Subject: RE: HDC / Brookvale Green - Land Inclusion Meeting

Brookvale Green – Preliminary Response to Council Officer Feedback

Title
**PROPOSED
ROAD / LANDSCAPE
RESERVE LOT CHANGE**

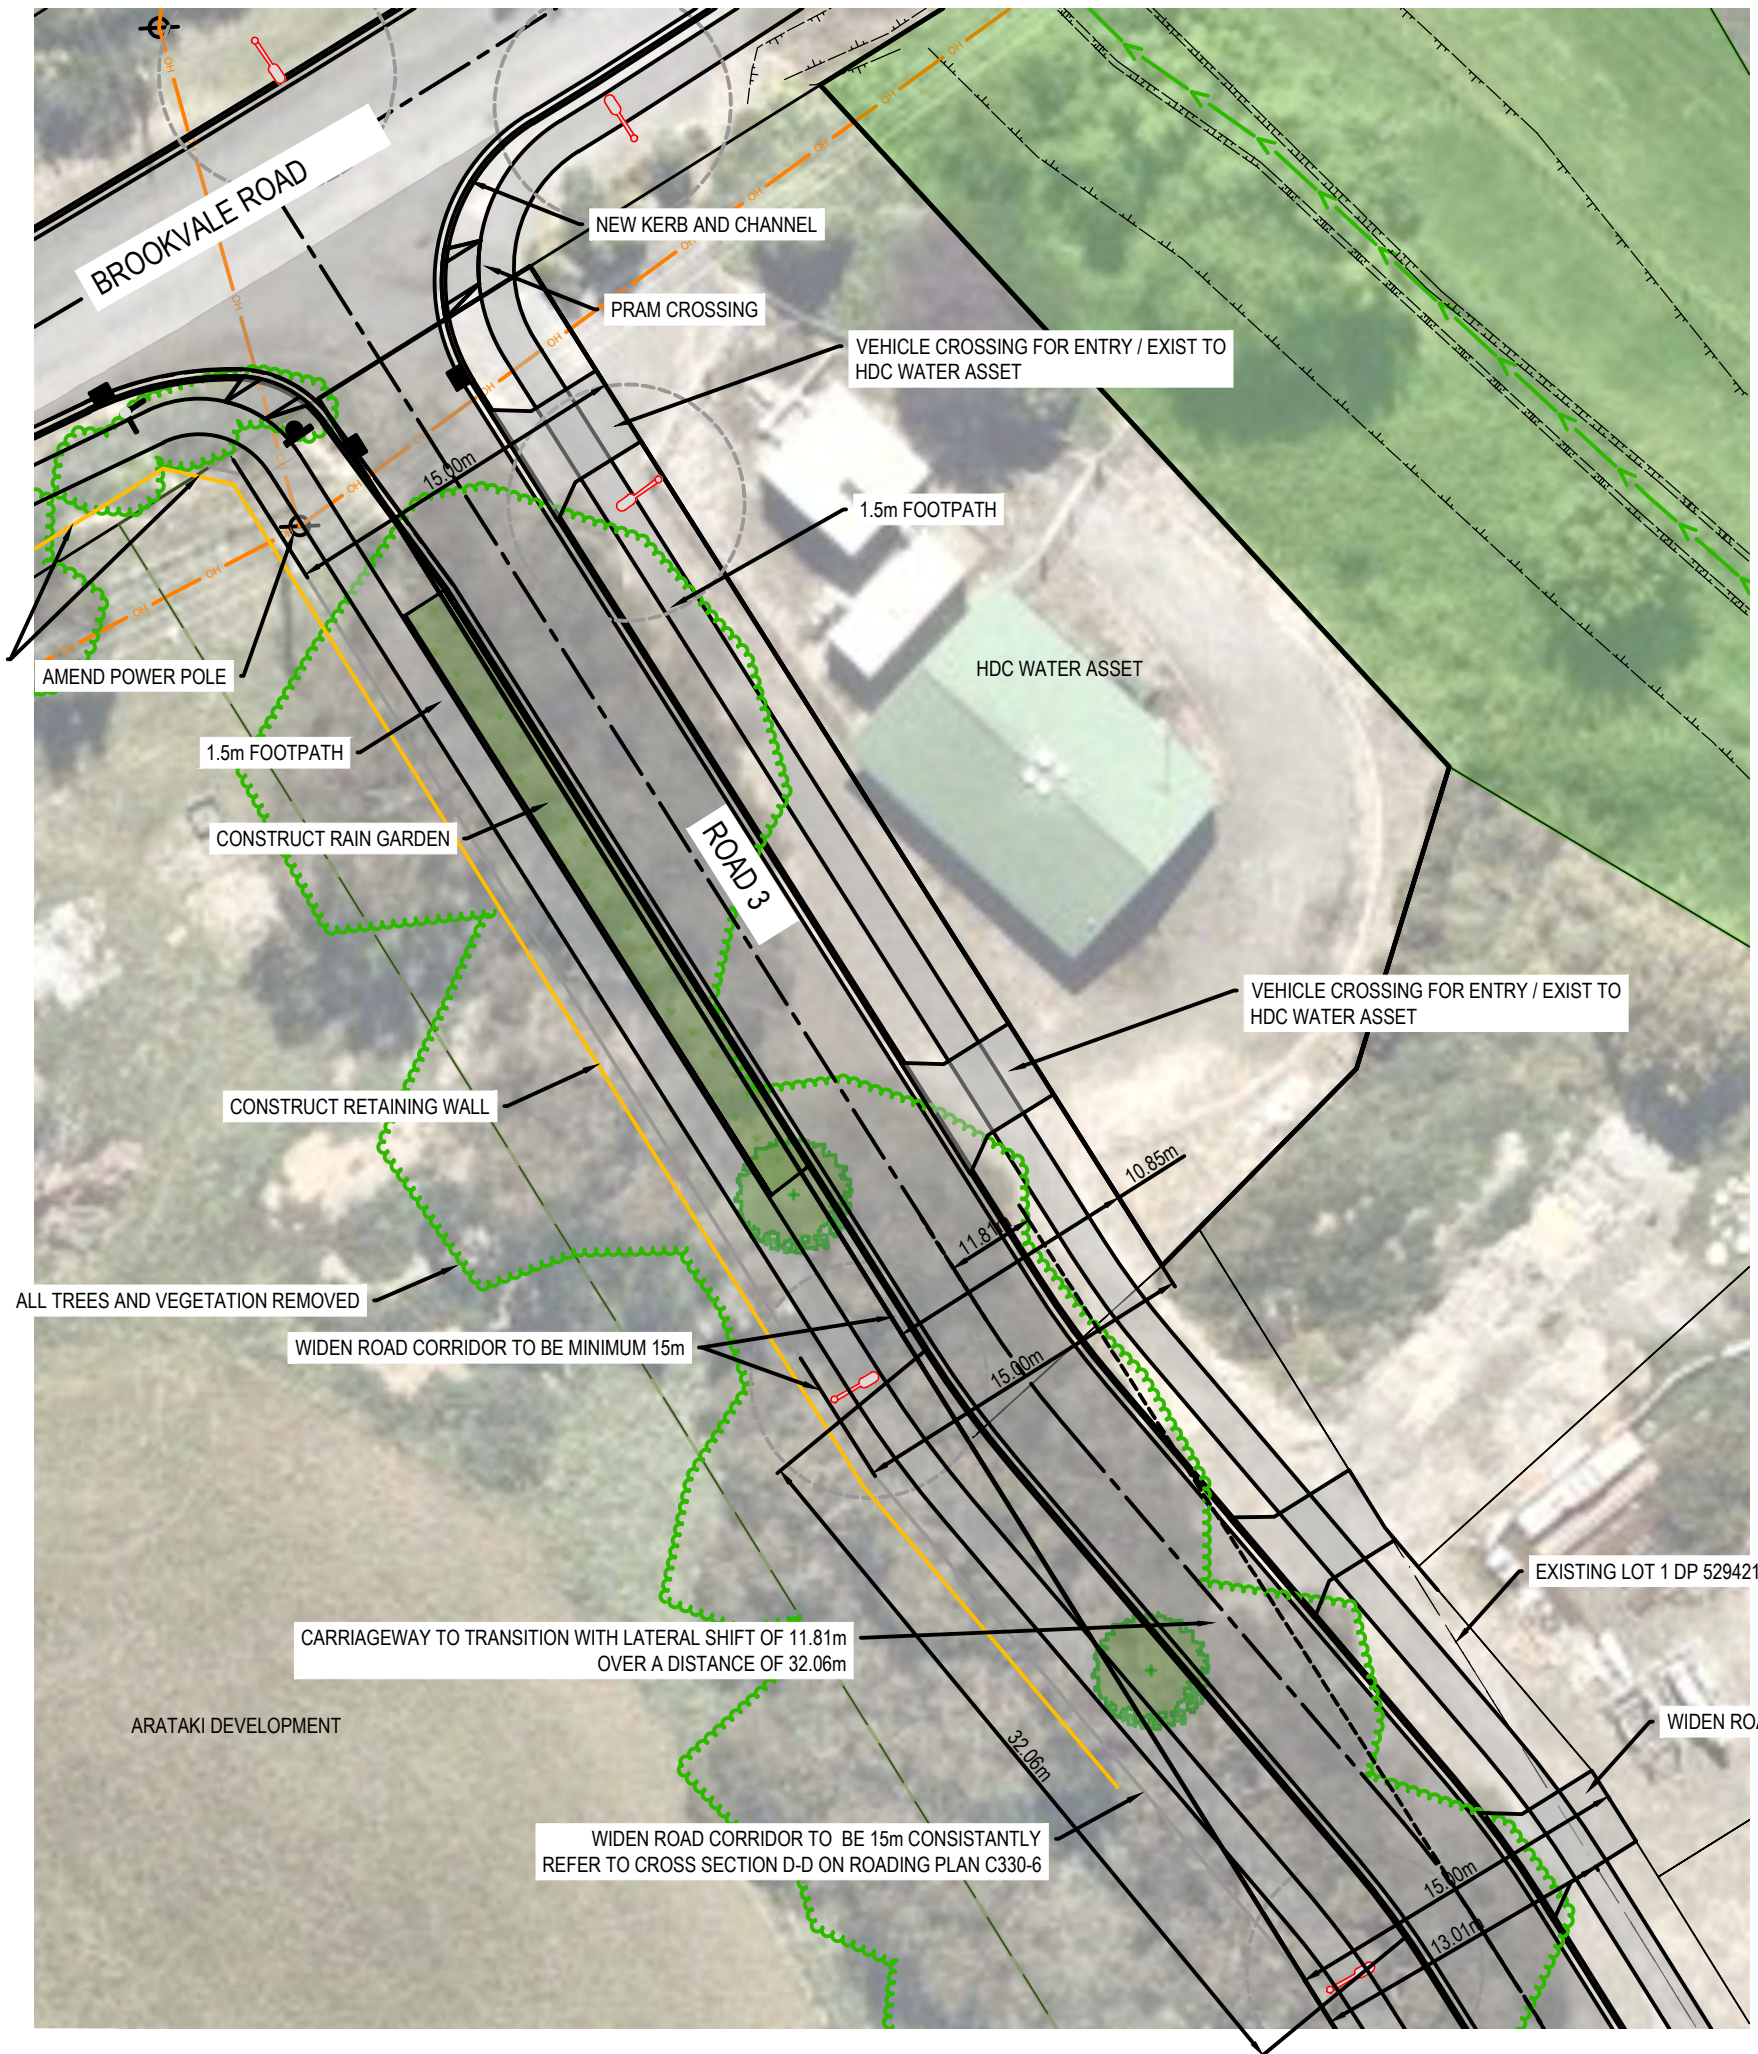
- [REDACTED] confirmed current access design shows 10.73m road reserve width
- [REDACTED] requires minimum 15m road reserve to meet engineering code of practice
- Road must be designed as two-way access to serve as secondary/emergency access for resilience
- [REDACTED] had not previously seen the access design plans
- Council willing to accept redesigned access if it meets code of practice standards

WIDEN ROAD CORRIDOR TO BE 15m CONSISTANTLY
REFER TO CROSS SECTION D-D ON ROADING PLAN C330-6

Title
**PROPOSED HDC
OWNED LAND
TO VEST AS ROAD**

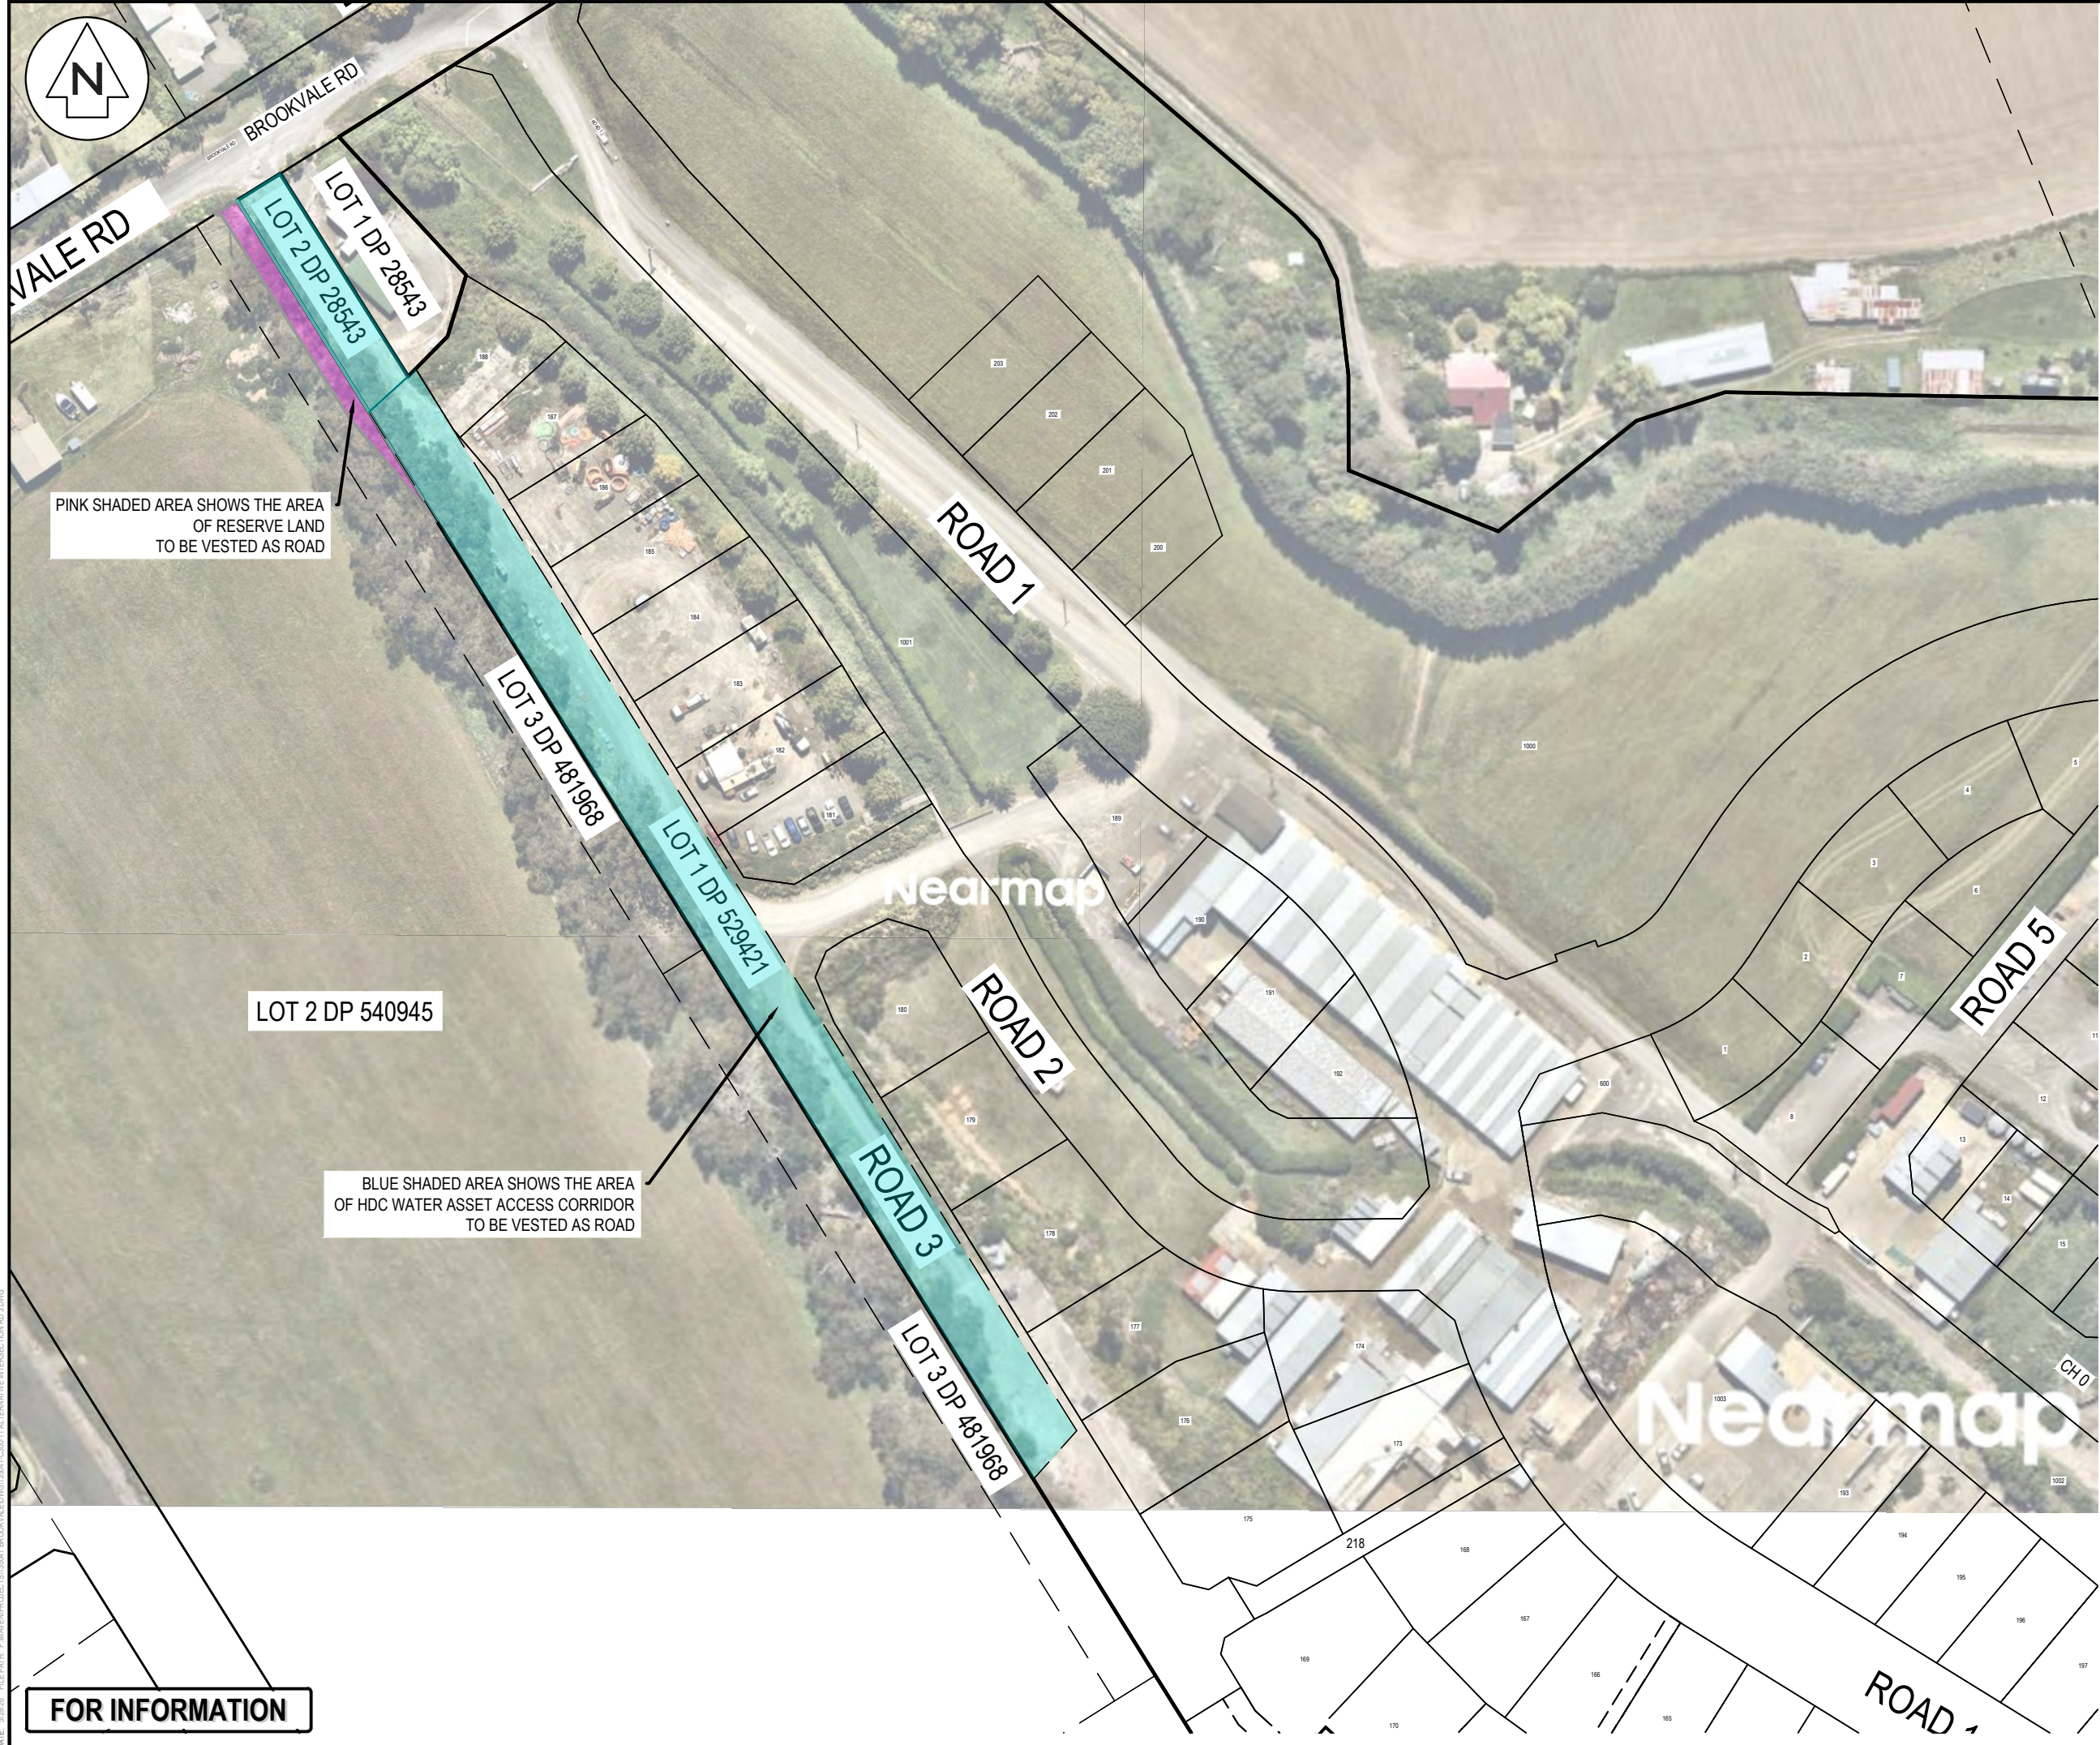
- Solution involves using reserve land (currently under Reserves Act) to achieve required 15m road width
- [REDACTED] confirmed willingness to incorporate reserve land into development if proper process followed
- Divestment requires Conservation Minister approval (typically delegated to council) and replacement of equivalent public green space elsewhere
- Fast-track panel has authority to handle Reserves Act matters without separate ministerial approval required
- Brookvale Green team confident this can be wrapped into fast-track application

PINK SHADED AREA SHOWS THE AREA
OF RESERVE LAND
TO BE VESTED AS ROAD

BLUE SHADED AREA SHOWS THE AREA
OF HDC WATER ASSET ACCESS CORRIDOR
TO BE VESTED AS ROAD

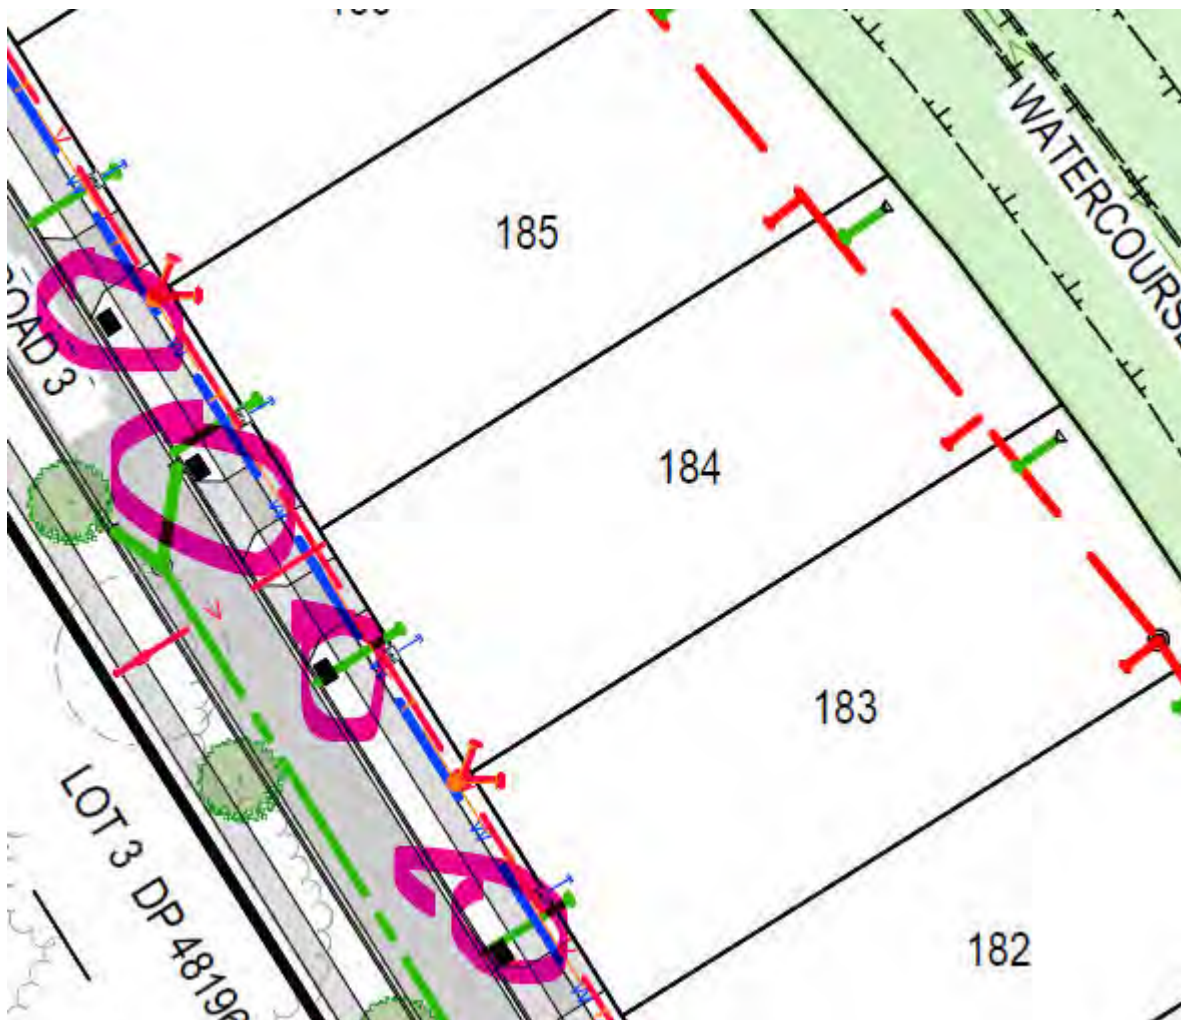
With 2), all refuse and recycling containers are placed on the front berm where that is available and all new design are to provide for that front berm. The HDC Engineering Code of Practice will give an idea of what width is required in that respect. The only recycling undertaken in the urban area of Hastings (Hastings / Havelock North / Flaxmere) is paper and cardboard, plastics and cans, and bottles. The refuse is in wheeled 120l bins that are picked up from the kerbside by mechanical arm on the truck and lifted to be tipped into the collection area of the truck from above it. The recyclables are handled and sorted into the truck by the contractor at the kerbface.

- 2) Can you please confirm if there is a waste collection programme in Havelock north which requires a suitable location to place a wheelie bin on the side of the road? And is that the same requirement for recycling collection? Do you have food scraps collection? Is there a minimum area which we need to reserve for the placement of bins for each dwelling in your area? In Auckland nowadays we have to provide 0.7 x 1.4m area, away from trees and close enough to the kerb for each new dwelling to ensure waste collection services can function properly.

The areas available for a wheelie bin / refuse / recycling have been added to the attached plan. Scale-wise it is a pretty small item so if you blink you will miss it. But if you scroll down the set and maybe zoom in you will see the location of the proposed bin locations which show that every lot will be able to use space in the berm on collection day without too much effort.
